CITY PLANNING COMMISSION

LOCATION: 1450 - 1454 Del Paso Boulevard

PROPOSAL: The applicant is requesting the necessary entitlements to locate an 86 seat restaurant in an existing structure located in the General Commercial (C-2) zone.

P87-312

EXHIBIT B SITE PLAN

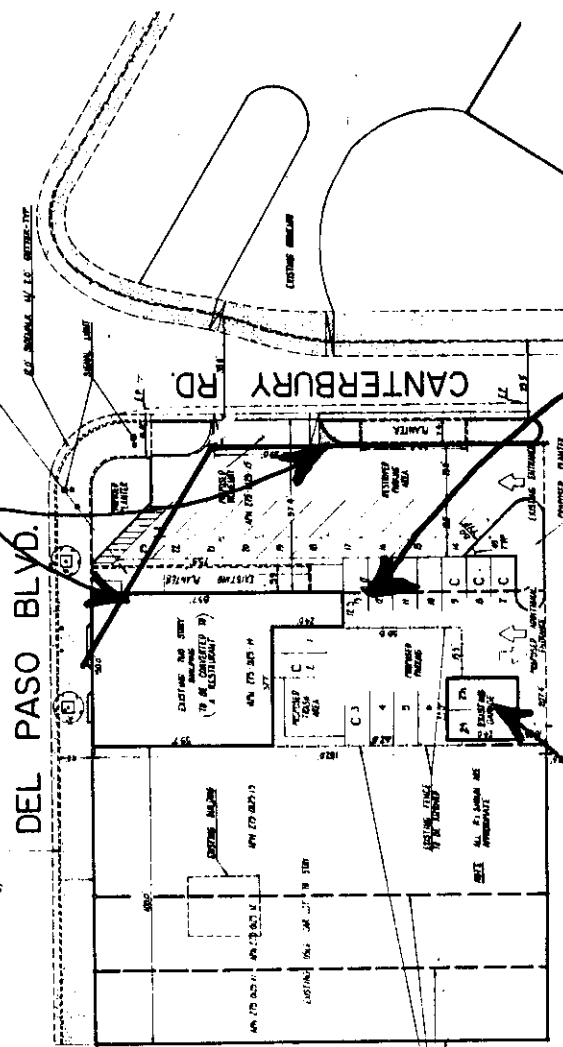
The applicant's site plan indicates 25 on-site parking spaces. The design of the parking lot, as proposed, however, has several spaces that do not comply with zoning regulations. Compact spaces 9 and 10 conflict with space 14 and cannot be counted. Spaces 1 and 2, behind the structure, require occupants to back out some 70 feet. This also does not comply with City regulations. Spaces 24 and 25 are located in a garage the applicant has indicated is intended for storage. These spaces technically cannot be counted for required parking.

Space 23, a corner of the structure, and the planter on the corner are located in public right-of-way. City Traffic Division indicated that a revocable permit would be required to allow parking and planting on this corner. Staff also recommends that a revocable permit be obtained from the Public Works Division to landscape City right-of-way along Canterbury Road.

Staff recommends that the garage on the site be demolished or relocated off-site. The stored items can be placed upstairs in the restaurant structure. This would create four spaces on the west parking bank and eliminate the conflict of spaces 8, 9 and 14. Additional space can be used for handicapped parking. Staff's recommendations will result in 24 on-site parking spaces and one parking space on City right-of-way.

Traffic - 10 ft. corner radius required at alley

Engineering - grading and drainage plan required

- alley improvement required

- frontage improvements required

1. The applicant shall obtain a revocable permit to locate landscaping in the City right-of-way on Canterbury Road and to locate landscaping and parking on the corner portion prior to obtaining building permits.
2. The garage at the rear of the site shall be relocated or demolished prior to obtaining building permits. That area vacated by the garage shall be striped with four spaces.
3. Detailed landscape and irrigation plans shall be reviewed and approved by staff prior to issuance of building permits.

4. Spaces 1 and 2, which do not meet City standards, shall be clearly marked as employee spaces.
5. A revised site plan indicating the above changes shall be submitted to staff for review and approval.
